**SECTION 4.55(1A) MODIFICATION APPLICATION
BUILDING R4A – ONE SYDNEY HARBOUR, BARANGAROO SOUTH**

This application has been prepared by Ethos Urban on behalf of Lendlease (Millers Point) Pty Ltd, pursuant to section 4.55(1A) of the *Environmental Planning and Assessment Act 1979* (EP&A Act) to modify Development Consent SSD 6964 relating to Residential Building R4A – One Sydney Harbour, Barangaroo South (the site).

Figure 1 Proposed changes to R4A Development boundary extent

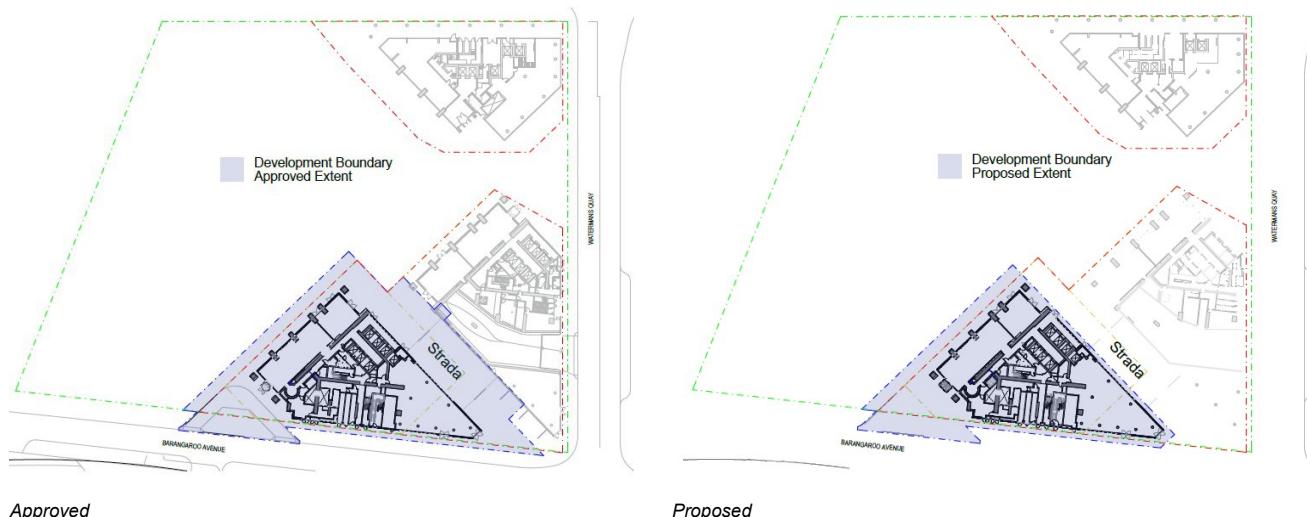
It is proposed to transfer the approved Strada (inclusive of ground plane and associated structure) from the Building R4A Development Consent (SSD 6964) to the Building R4B Development Consent (SSD 6965) so that the entirety of the Strada, including the ground plan and the roof structure above it, sits within the same development consent. Currently, the ground plane and associated wind management elements are located within the R4A consent, and the Strada roof within the R4B consent.

To accommodate this amendment, the development boundary of Building R4A has also been modified so that it no longer incorporates the Strada, as shown in **Figure 1**. The relevant conditions relating to the Strada are sought to be deleted from the Building R4A consent (SSD 6964) and are to be captured within Development Consent 6965 (as modified) under a separate modification application.

Figure 2 Proposed removal of trees on ground plane

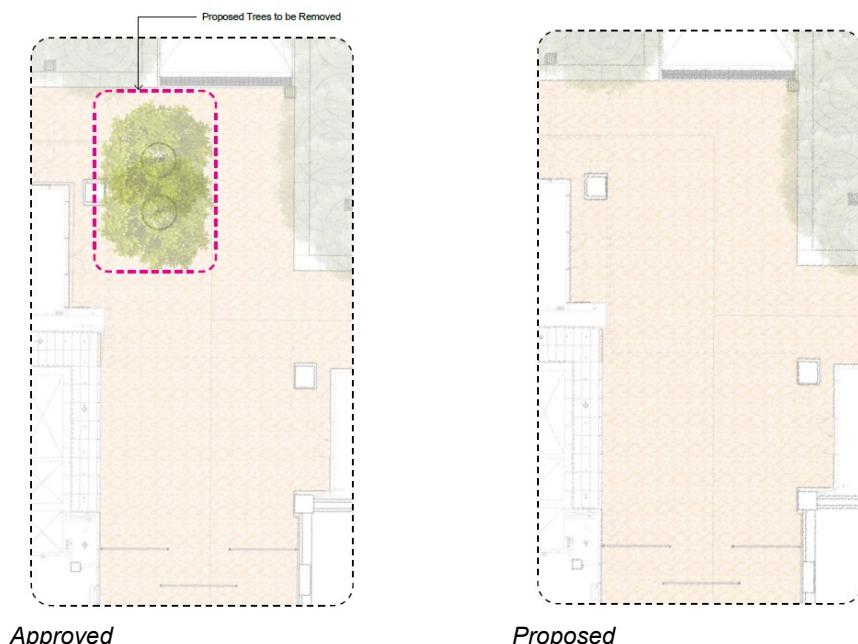
It is proposed to remove two trees adjacent to the tenancy facing Hickson Park, improving pedestrian access and visual connectivity at the ground plane, and ensuring cohesion with the Barangaroo Public Domain (SSD 7944) design and character. The trees identified for removal are shown in **Figure 2** below and are illustrated in the Landscape Drawings prepared by McGregor Coxall (refer to **Attachment B**).

The two trees nominated for deletion formed part of the original development consent for R4A approved in 2017, prior to the design and approval of the adjoining Barangaroo Public Domain (including Hickson Park) in 2018. The approved Public Domain design provides a substantial tree belt around the towers, with clear open paved areas to encourage visual and physical connectivity from the park through to the Strada. The location of the two trees inhibits this clear line of sight and pedestrian access, and their removal will provide a more consistent public domain outcome.

It is also noted that wind consultants Windtech have reviewed the impact of removing these two trees and confirmed it will result in negligible impact on the wind environment, as discussed further at **Attachment I**.

Figure 3 Proposed changes to ground floor entry vestibule

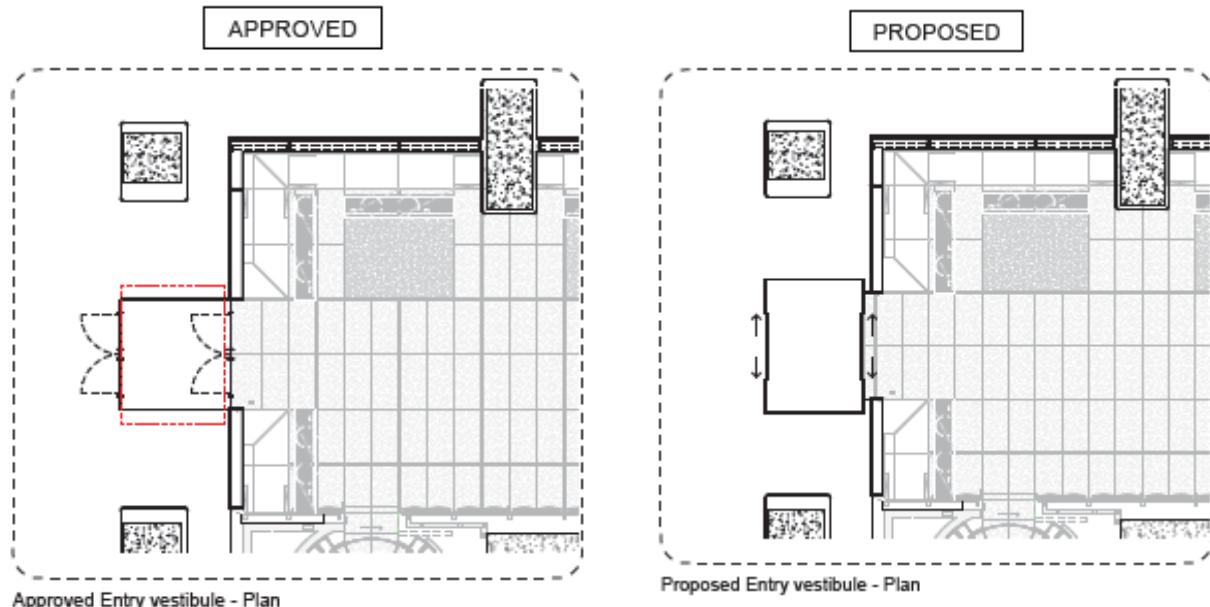
As a result of ongoing design development, the configuration of the entrance vestibule is proposed to be revised to provide a simplified and improved architectural response to the façade. Specifically, automated sliding doors have been integrated in lieu of swing doors, improving operation as well as creating a seamless transition from outside to the residential lobby interior.

This amendment results in a minor adjustment to the dimensions of the lobby vestibule. This amendment has been integrated into the modulation, proportion and geometry of the façade to provide a design response that meets the design standards of the precinct architecture.

Figure 4 Proposed amendments to the building identification signage zone of R4A

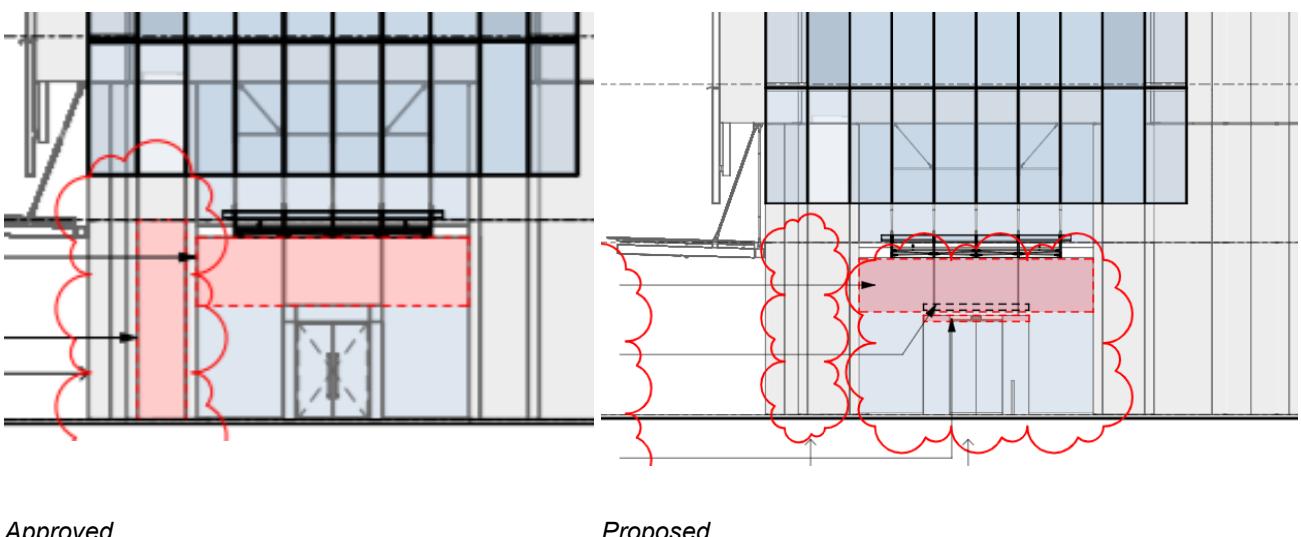
Due to the changes described above relating to the entry vestibule and further design studies undertaken, minor amendments are required to the approved building identification signage zone located above the entrance. The approved signage zone encapsulates an area above the swinging doors and a section adjacent to the doors. Due to the removal of the swinging doors and further design development, three signage zones are now proposed to reflect the current arrangement. These include a zone on the upper portion of the glass entry way, on top of the glass entry way and the existing approved zone above the entrance vestibule. It is noted that whilst three signage zones are proposed, only one will be utilised for detailed signage, subject to the final design of the building.

Figure 5 Proposed reconfiguration of apartment of Level 58

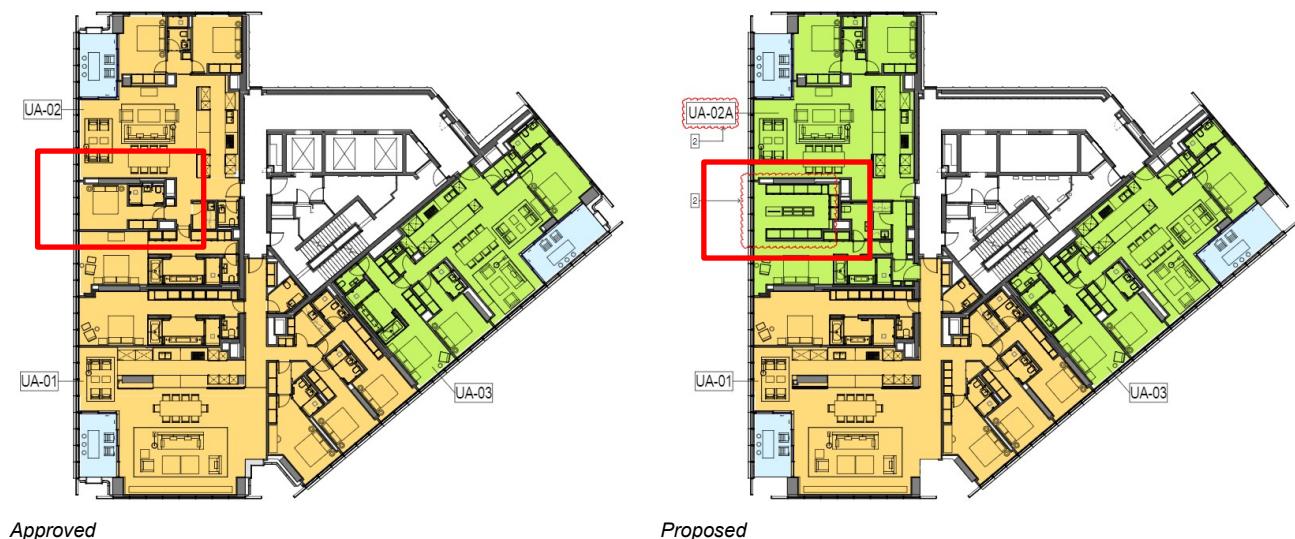
It is proposed to convert a four-bedroom apartment on Level 58 into a three-bedroom apartment by converting an existing bedroom into a walk-in wardrobe. This amendment will not result in any additional GFA, and is simply a reallocation of previously approved space for a different purpose. The proposed amendment is highlighted below in **Figure 5** and is also illustrated in the Architectural Plans at **Attachment A**. The adjusted dwelling mix in light of this change is also provided in **Table 2**.
